NURSING PROGRAM EXPANSION

WILLEY LIBRARY • JOHNSON CAMPUS

January 23, 2026

END OF ADDENDUM #2

DOOR ELEVATIONS

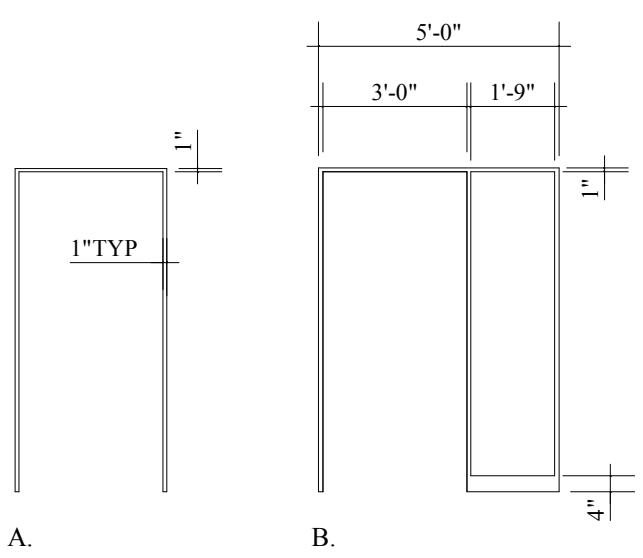
Drawing A-1.1 & A-5.0 show clouded Revision 1. Revision 1 changes the door size and frame at Doors 217.1, 233 & 242. Refer to attachment for revised Drawings & Hardware Sets.

△ CHANGES TO DOORS 217.1, 233, 242
